Technical Service Bulletin: TSB190225	Released Date: 19-Feb-2020
Campaign #4035: Fix for C100D2RE Generator Set Paralleling Control Wiring Issue

- C100D2RE

Figure 1, Harness A054R546 with P70 and J40 highlighted

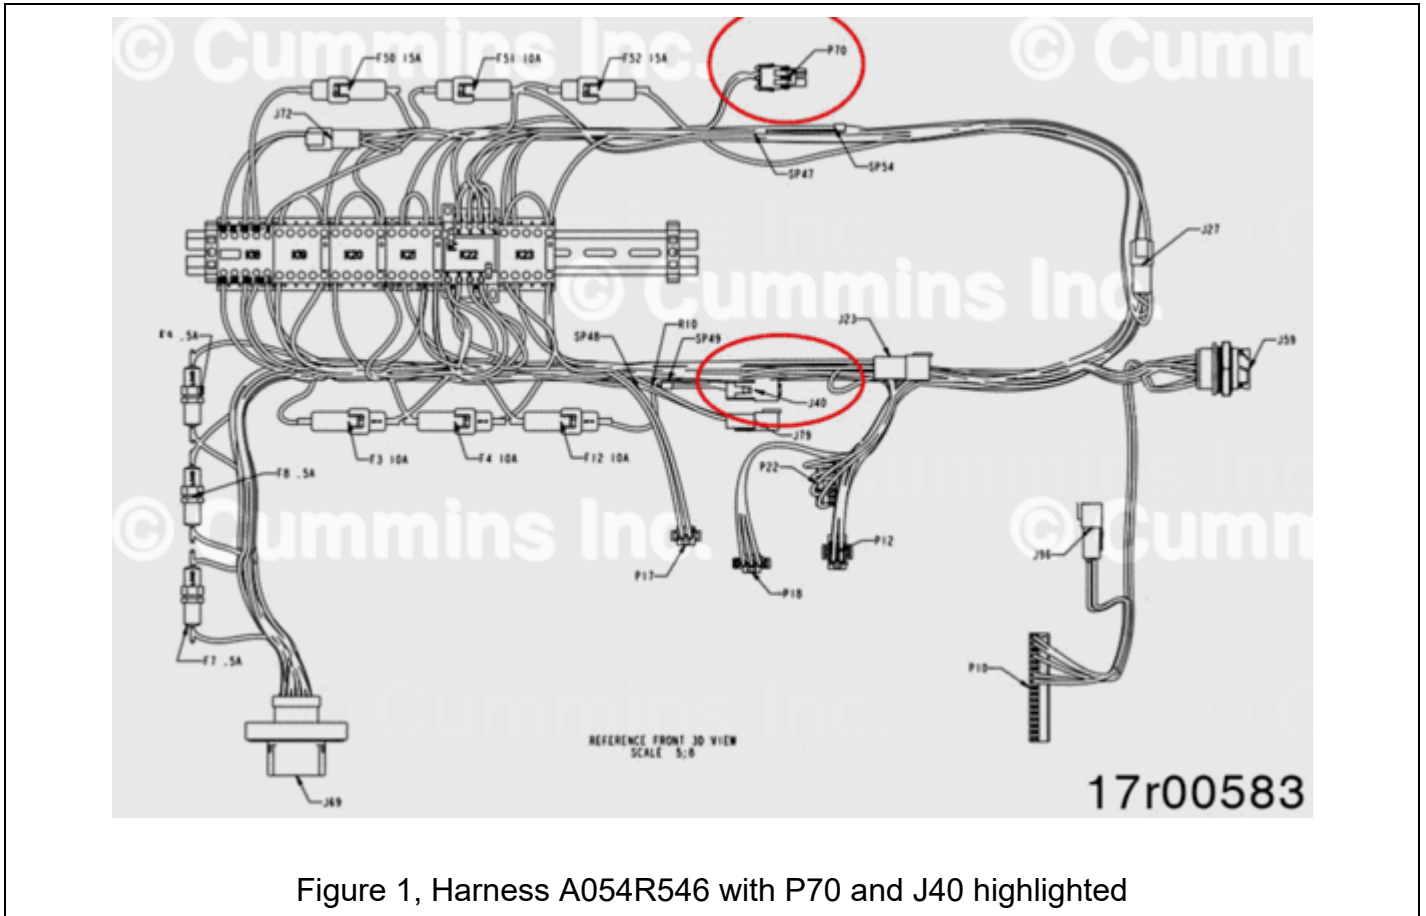
When a C100D2RE generator set is attempted to parallel with a C150, C200 or C275 generator set, the B+ (24 VDC) on the two units short with each other, as a result of which the units cannot be paralleled, and temperature of the paralleling cable rises.

- Due to a design error in C100D2RE generator set harness, paralleling C100 with any other models causes the B+ (24 VDC) from one unit to be shorted to B+ on the other unit

1. Swap P70-A and P70-B
2. Swap J40-1 and J40-2

1. Swap P70-A and P70-B
2. Swap J40-1 and J40-2

Figure 2, Location of connectors P70 and J40 on harness

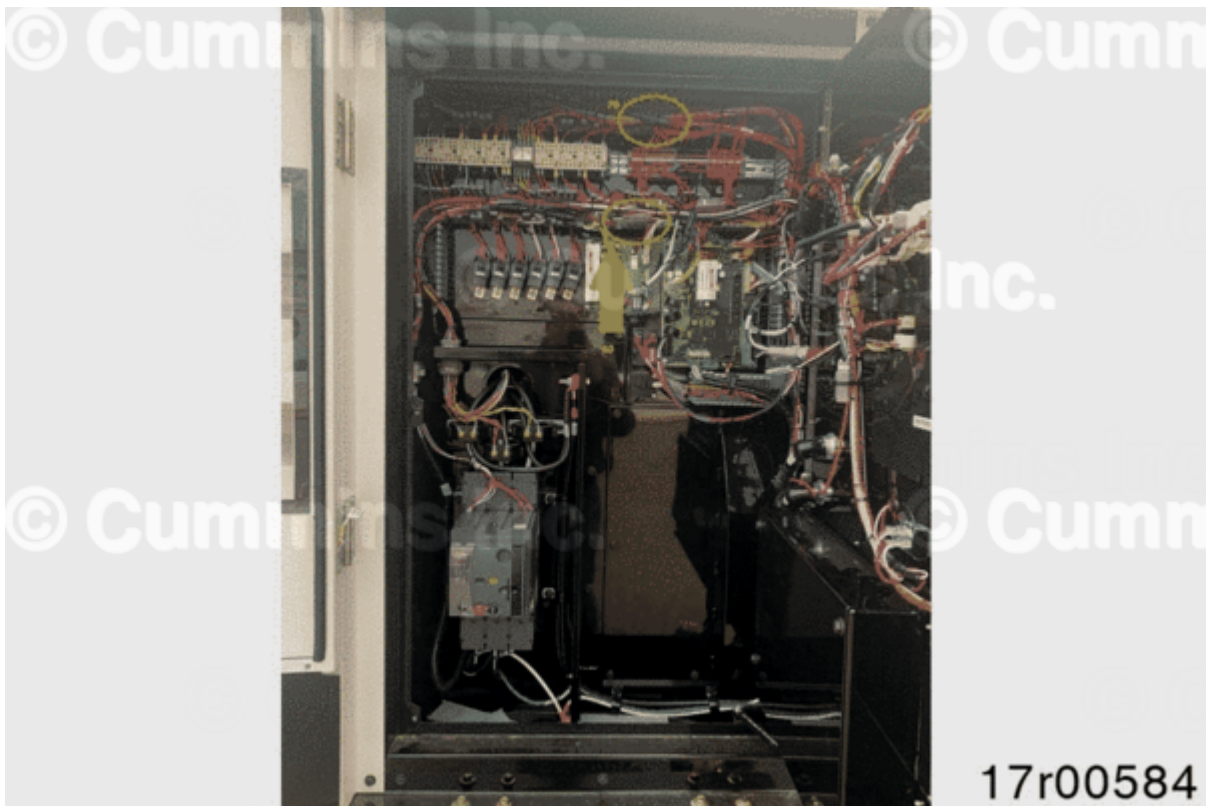
The harness is in the front panel inside the top rack of generator set. To locate connectors P70 and J40 with respect to the harness, refer to Figure 2.

Figure 4, Terminal Remover Tools

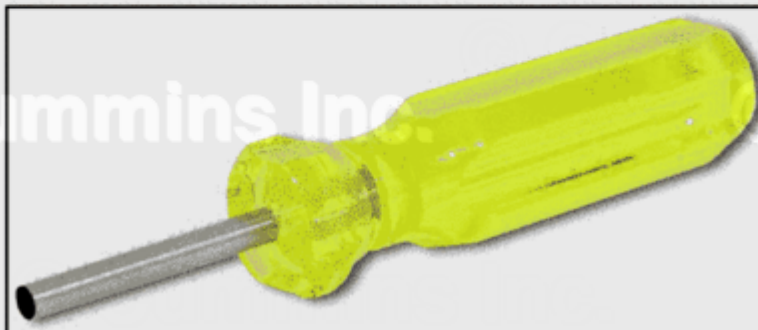
1. Swapping connections of P70 connector (PN: 0323-1637) requires a Terminal Remover tool (refer to Figure 4 for examples) to remove the wires and reconnect them in the right location. Unplug the side clip on P70 connector as shown in Figure 3, before inserting the tool to remove wire connectors.

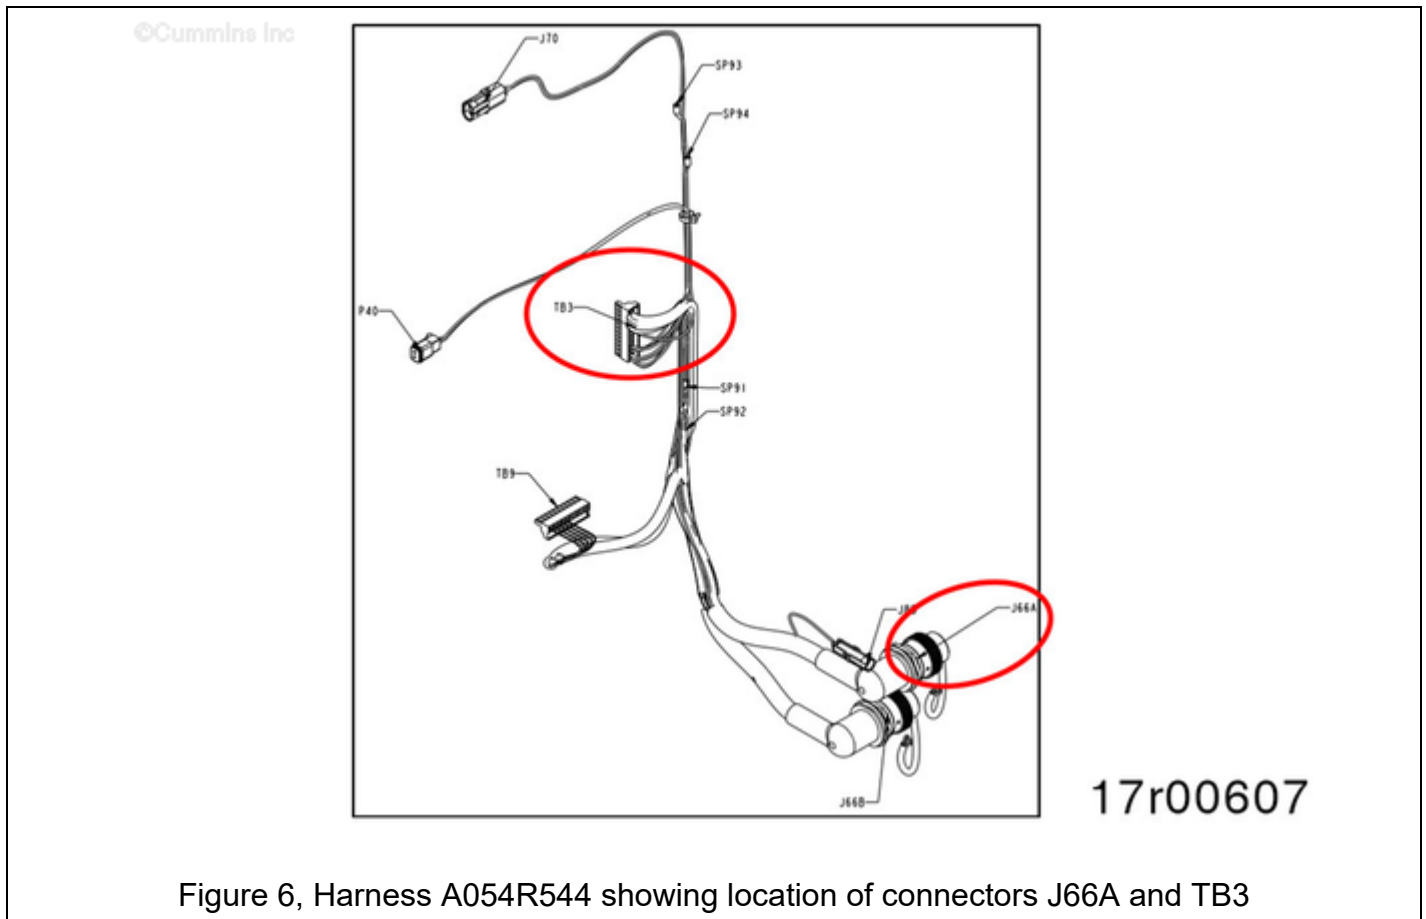
Confirm the fix performed above by checking for continuity on the terminals between harnesses A054R544 (Figure 6) and A054R546 (Figure 1) indicated in Table 1, by using a multimeter.
